**MACEDONIA PLANNING COMMISSION  
PUBLIC HEARING  
NOVEMBER 21, 2022**

**MACEDONIA PLANNING COMMISSION  
MEETING AGENDA  
NOVEMBER 21, 2022**

**TO:** Nicholas Molnar, Mayor  
and Macedonia Planning Commission

**SUBJECT:** Chipotle Drive-thru Addition (revised plans) – 8195 Golden Link Blvd.

PROPOSED NORTH ELEVATIONS OPTION 1 & 2

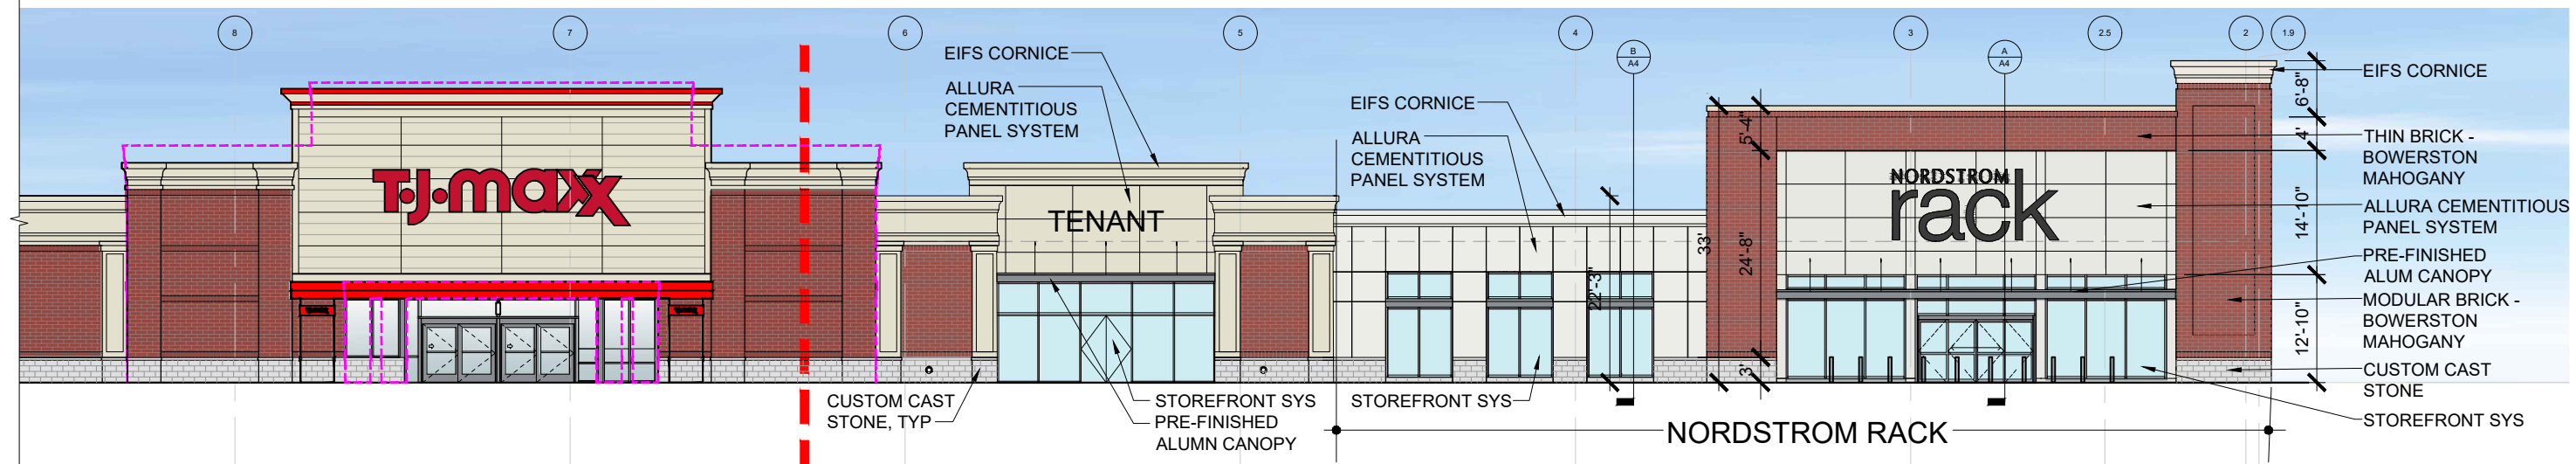
- 1) A very different corner element is being proposed as compared to what the Planning Commission approved at the on-set of this project. This particular element is essentially a rectangular box and massed similar to the other units. However, the original Commission approval provided a gabled tower element, which is more appropriate for the Western Reserve style of architecture utilized throughout the City. Conversely, the lack of a pitched roof element with this proposal is out of character with Western Reserve Architecture and should not be considered for approval.

3. The details in drawing (04) option 2 show soldier course brick details which add to the three-dimensional quality celebrated in Macedonia. Please utilize these details where possible. However, Option 2 as shown is not preferred due to the unbalanced look of the “tower”. Utilizing a gabled tower would introduce a different element which could allow “visual acceptance”. As previously stated, I believe a gabled tower is appropriate for this location.

**PROPOSED WEST ELEVATIONS OPTION 1 & 2, SOUTH ELEVATION**

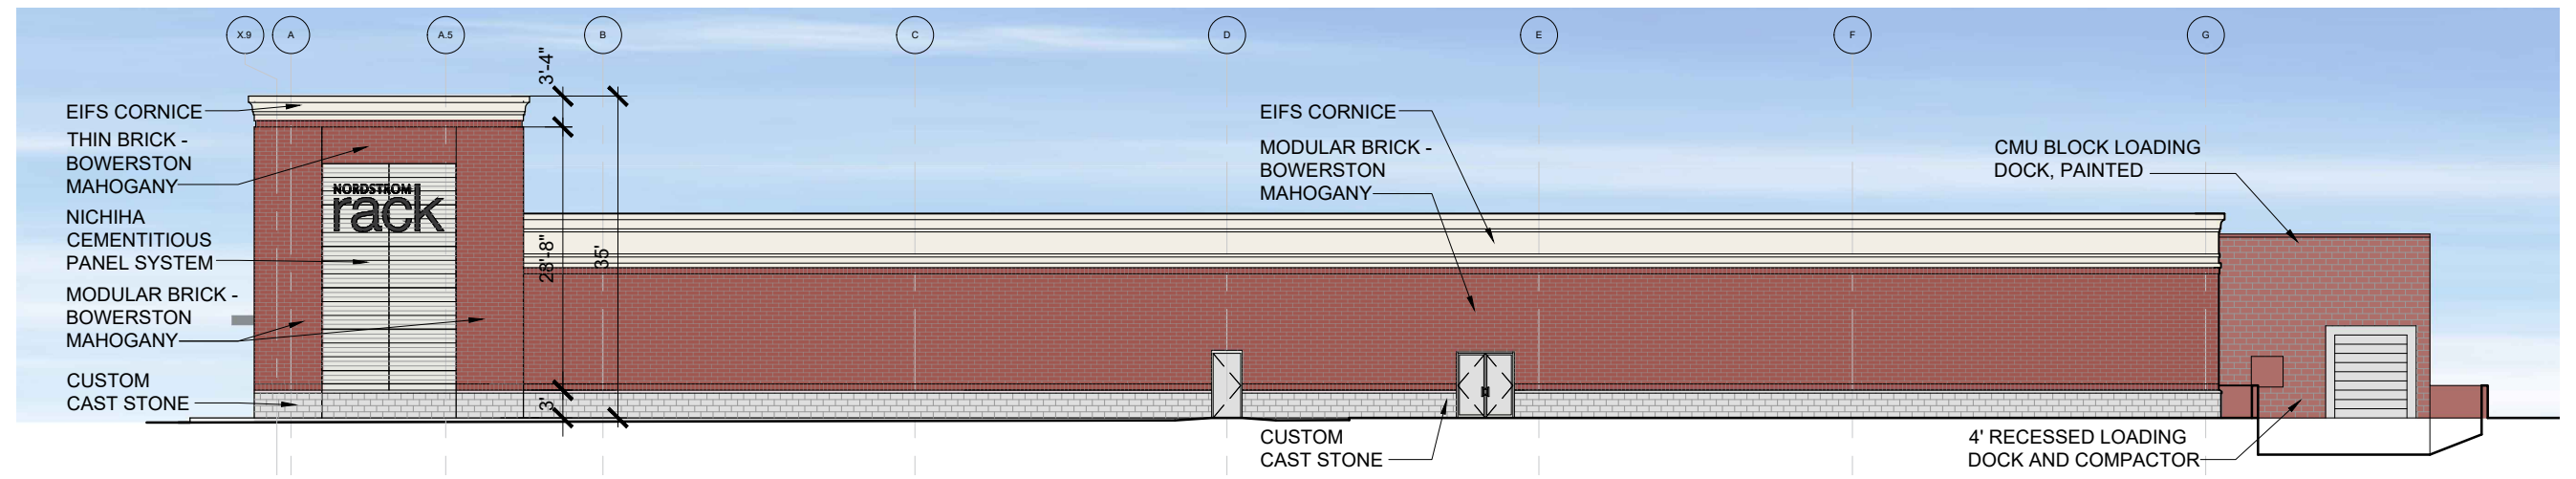
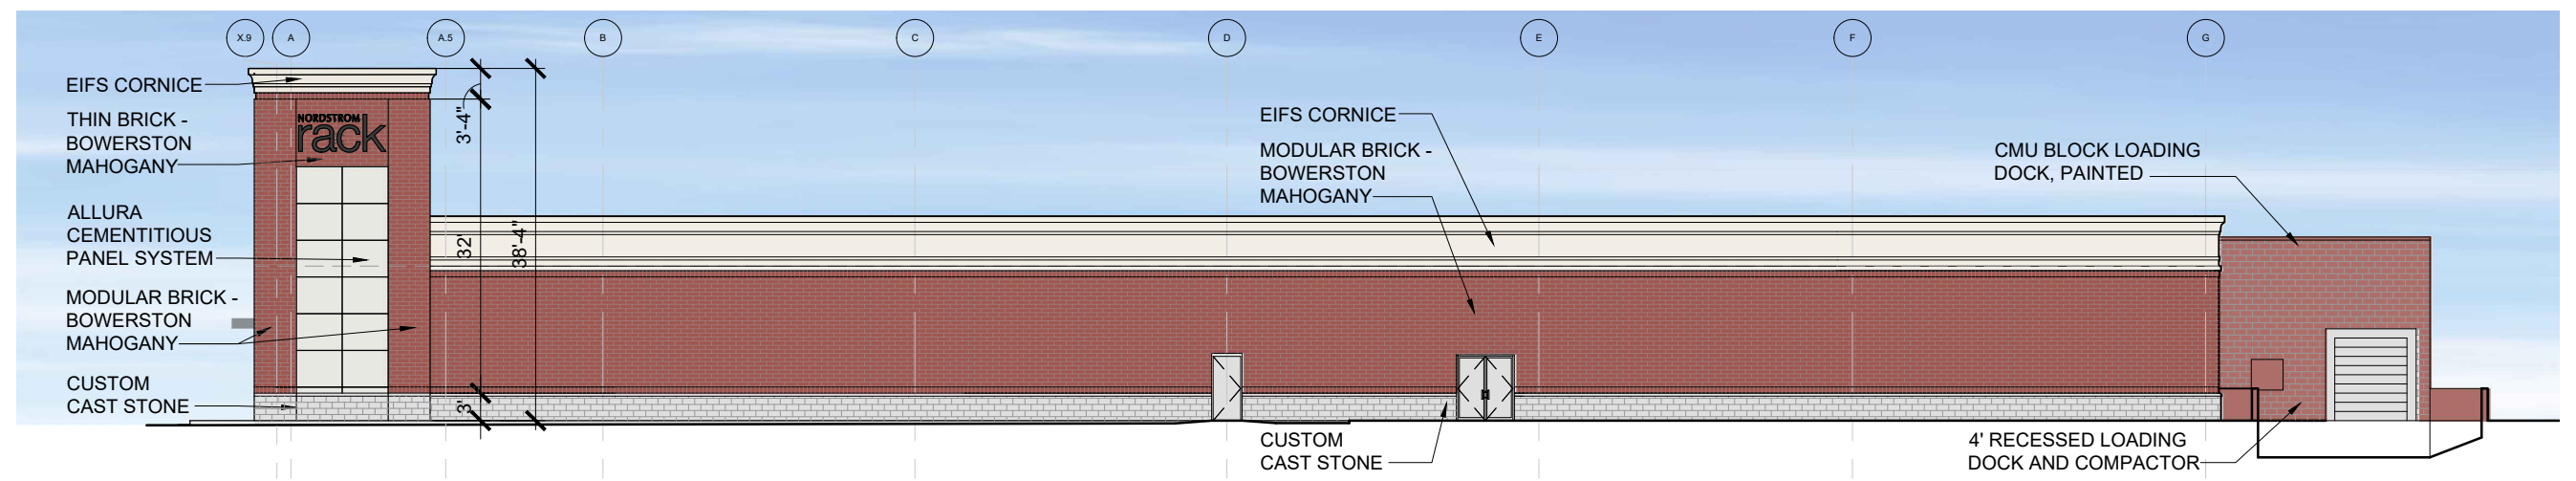
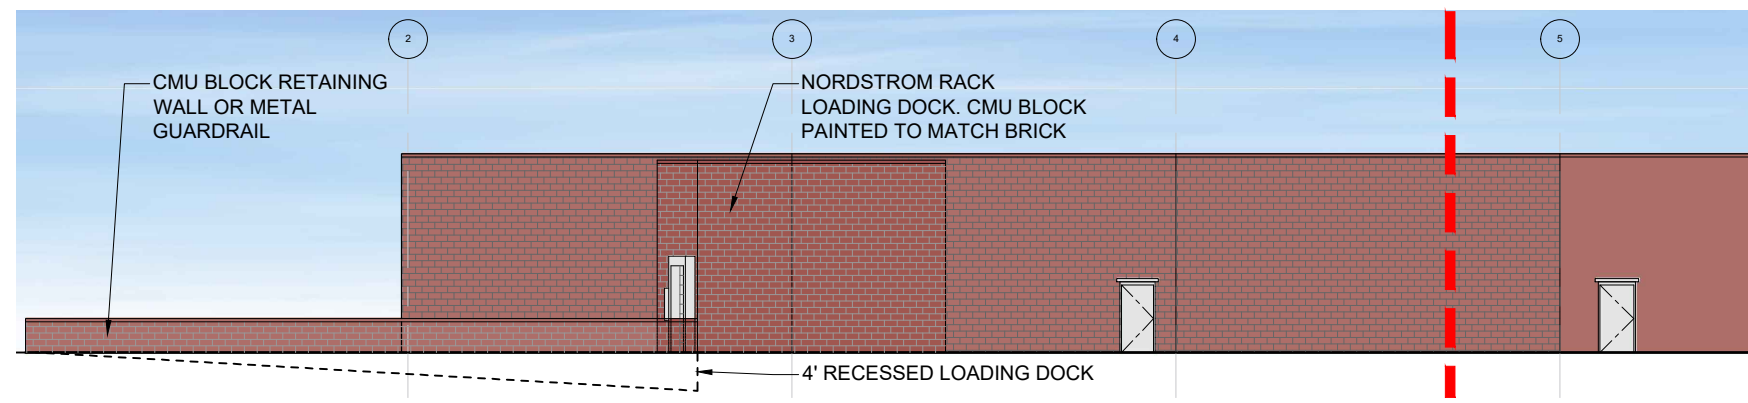
- 3) The western building wall is very long and devoid of architecture. Some level of fenestration and detail must be provided on this elevation to ensure a meaningful presence fronting on State Route 8. Two options are presented by the applicant for the corner element on this elevation. My position still is that the gabled tower element is more aligned with Western Reserve Architecture, as opposed to either option presented.

9. The Western Elevation showing the larger tower would be preferred due to the high visibility. The cementitious panel system should be installed in a brick pattern to add to the Western Reserve details required by the City of Macedonia.
10. Adding three dimensional/soldier course details on the long Western Elevation facing route add would add visual interest instead of the large cornice detail. (minimizing the amount of dryvit at the cornice is required).
11. Painted cement at the dock area may create future maintenance issues. Please verify maintenance program.
12. The EIFS cornice and the cement panels should have similar colors. The Nordstrom rack façade has an area where the two materials butt against each other. (color samples in the picture show they could clash. Please verify colors in person).

## LANDSCAPE EXHIBIT - ENLARGED PLANS

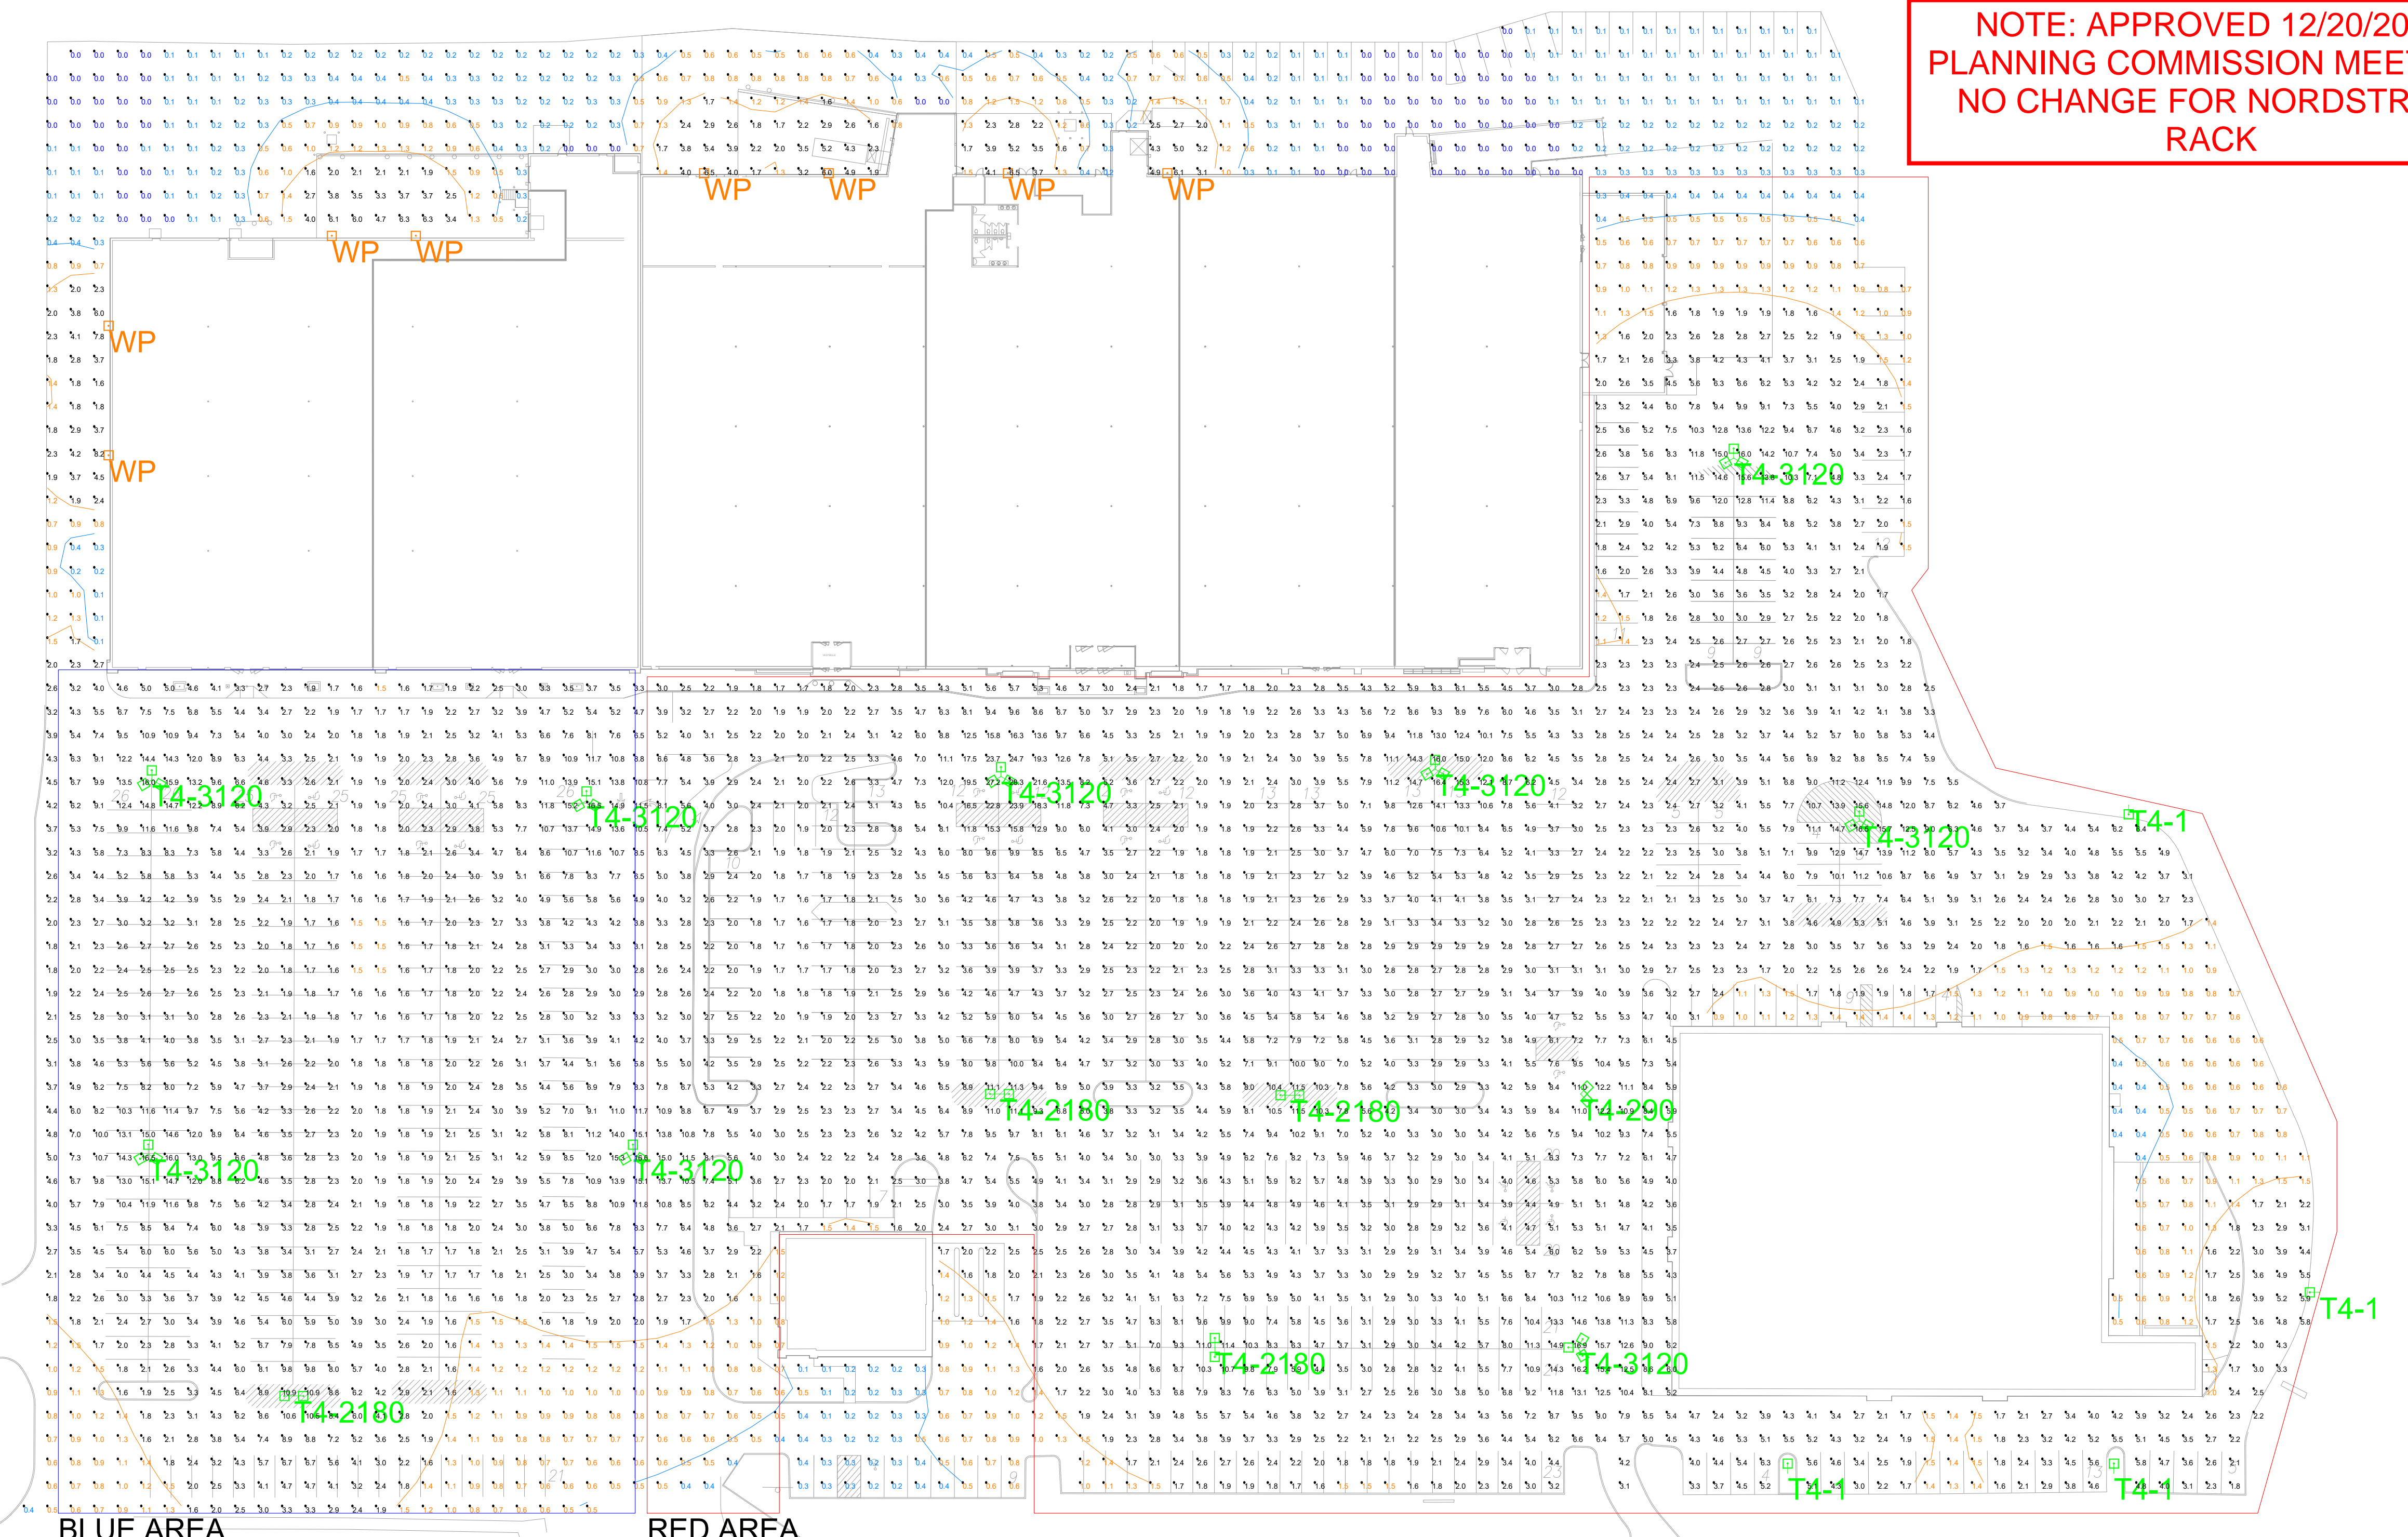
- 8) The landscape exhibit shown on Sheet 8 appears to be different than the December 2021 approval. My recollection is that additional trees were added in the islands and a different variety of landscape species was approved by the Commission based on requests I presented in my November 2021 report. For ease of review, my November 2021 comments are noted below in italics font. I don't believe the Commission's approval based on the comments below are reflected in the details shown on Sheet 8 of this submittal. The applicant should confirm the correct details.
